PRODUCT CHANGE | CROWN & DRIVE SET 35MM MOTOR IN 2" TUBE

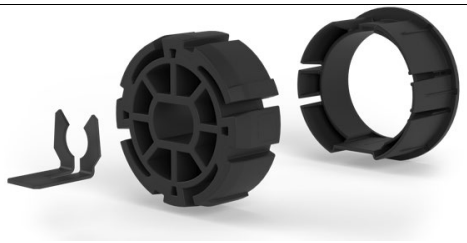
DISCONTINUED PRODUCT	REPLACEMENT PRODUCT	CHANGES MADE YES	CHANGES MADE NO
DESCRIPTION.	CROWN & DRIVE SET 35MM MOTOR IN 2.0" RIBBED TUBE	CROWN & DRIVE SET 35MM MOTOR IN 2" TUBE	☑	☐
CODE.	MTCRDR-35-2	MT03-0111-050003	☑	☐
PACK SIZE.	10|100 EA	10|100 EA	☐	☑
COLOUR / FINISH.	White - 069	White - 069	☐	☑
IMAGE.			☑	☐
USE WITH.	All 35mm Motors		☐	☑
TRANSITIONING.	**November 2025**

- Compatible with Rollease Acmeda 2” Tube (RTEA5U16)
- Improved assembly and fitment process resulting in reduced production time.

- The crown and drive wheel features a tighter grip within the tube avoiding unwanted movement.

- Improved design, enhancing tube fitment and a more efficient shade assembly.
